Subject: Richardson Fee SWD

**From:** Jones, William V., EMNRD  
**Sent:** Friday, November 05, 2010 5:13 PM  
**To:** 'dkdllc@leaco.net'  
**Cc:** Ezeanyim, Richard, EMNRD; Gonzales, Elidio L, EMNRD; Hill, Larry, EMNRD  
**Subject:** Disposal well - Packer setting depth: Richardson Fee SWD #2 30-025-27886

Subject: Richardson Lease, API #30-025-27886

Well History Summary Sheet

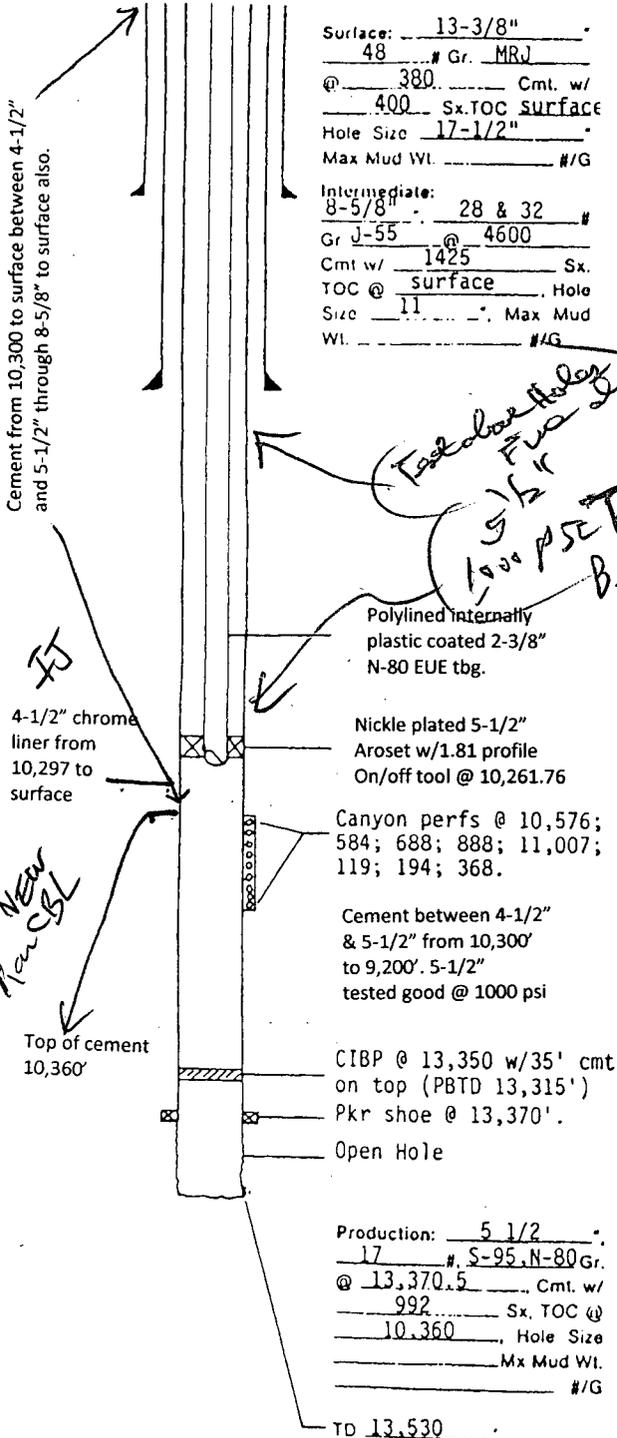
Would you send a wellbore diagram of the well after the liner was installed. I am especially interested in the cement condition and top behind the old casing. It appears you have addressed the interior of the well with the new liner. The sundry you sent had one sentence about cementing on 9/10/2010 – there likely is more to the story and a diagram is always good.

The original well history diagram and a revised diagram follow for your information. I have also included copies of the cement company's (O-TEX) job log and job summary reports to verify the cement-job information. In addition, I have provided information on the Richardson Unit #2 well which is the closest well to my Richardson SWD. This information is proof of the depth of the Richardson Unit #2 and its permitted zones. Area plats of the location are also provided.
